HISTORIC AND DESIGN REVIEW COMMISSION

HDRC CASE NO: 2023-223
COMMON NAME: 1304 E HOUSTON ST
ADDRESS: 1304 E HOUSTON ST
LEGAL DESCRIPTION: NCB 574 BLK B-13 LOT 31 MERCHANTS SUBD
ZONING: D
CITY COUNCIL DIST.: 2
APPLICANT: Andrew Douglas/Douglas Architects
OWNER: Pat Kennedy Jr./TPB Merchants MM, LLC
TYPE OF WORK: Construction of a parking structure
APPLICATION RECEIVED: June 02, 2023
60-DAY REVIEW: August 01, 2023
CASE MANAGER: Edward Hall

MERCHANTS ICE GARAGE

HDRC REVIEW FOR CONCEPTUAL APPROVAL

MERCHANTS ICE GARAGE | NORTH ELEVATION

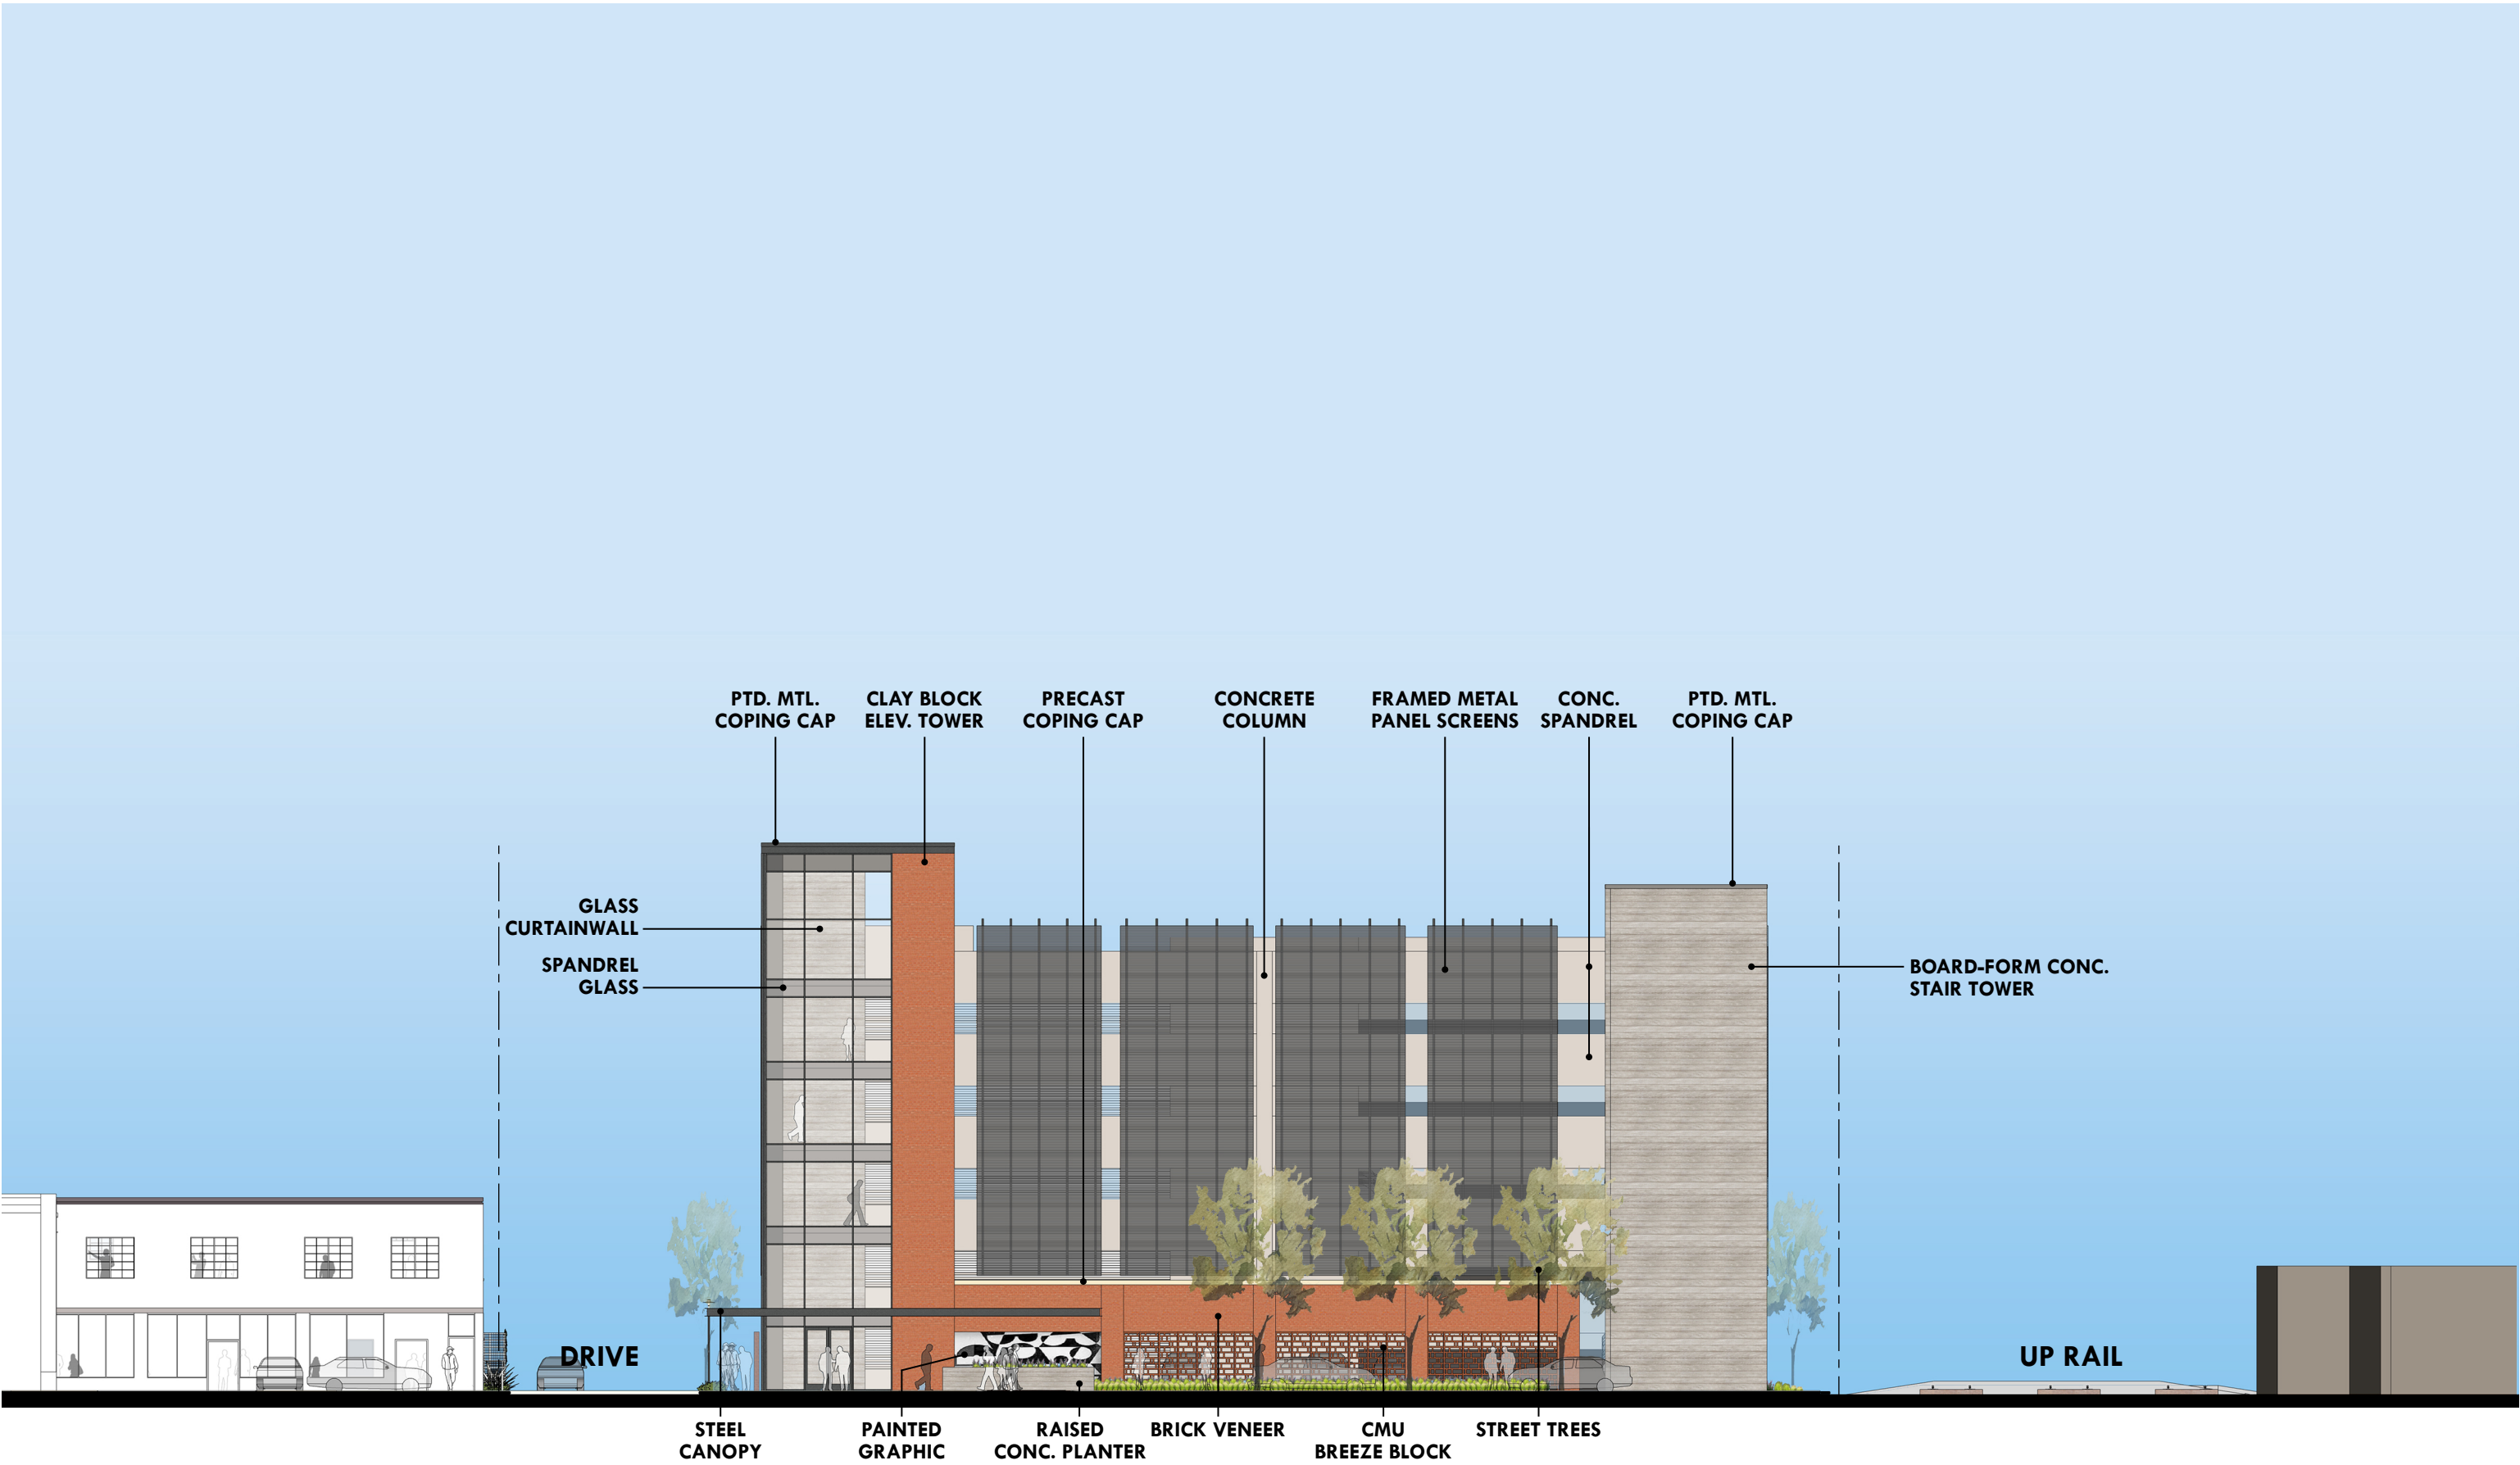
- c. **FAÇADE DESIGN** – The Downtown Design Guide, Chapter 4, Section B.1. notes that parking structures shall have an external skin design to improve visual character when exposed to prominent public view. The Downtown Design Guide notes that this can include heavy-gauge metal screen, pre-cast concrete panels, live (landscaped) walls, laminated glass or photovoltaic panels. The applicant has proposed for the primary façade, facing E Houston to feature spandrel glass, clay block, framed metal panel screens, brick columns, and board-form concrete. The east and west facades feature those materials, plus metal fins (east façade) in limited locations. The south façade is currently void of additional façade materials. Generally, staff finds the proposed materials to be appropriate; however, staff finds that additional façade elements should be added to both side facades (east and west) and the rear façade. Vertical façade elements should be incorporated along the full length of each façade.

- e. **GROUND FLOOR TREATMENT** – The Downtown Design Guide, Chapter 4, Section B.4. notes that ground floor treatment of parking structures should activate pedestrian oriented public streets as specified in Chapter 3; active spaces should be used along streets. On all other streets the ground floor treatment should provide a low screening element that blocks views of parked vehicle bumpers and headlights from pedestrians using the adjacent sidewalk. The intent of the Downtown Design Guide is for retail space to be located at the ground level of all new construction. Staff finds that the E Houston Street façade at the ground level should be fully designed to appear as an active space. Storefront systems should extend along the E Houston façade at the street level, particularly beneath the pedestrian canopy that has been proposed. If storefront systems are not designed to be appear as active spaces, staff finds that the applicant should incorporated a greater street setback and street trees, as noted in finding i.

- i. That vertical façade elements be added the complete length of each façade, as noted in finding c.
- ii. That the E Houston Street façade be fully designed to appear to feature active space at the ground level, as noted in finding g. Storefront systems should extend the E Houston Street façade, particularly beneath the proposed pedestrian canopy. An alternative solution would be to install evergreen street trees as a screening solution as noted in finding i.
- iii. That signage and public art be developed as specified in the Downtown Design Guide, as noted in findings f and g.
- iv. That building lighting be designed in a manner that does not produce light pollution. Top level lighting should be supplied via wall sconces and not light poles.
- v. That all landscaping elements adhere to the Downtown Design Guide.
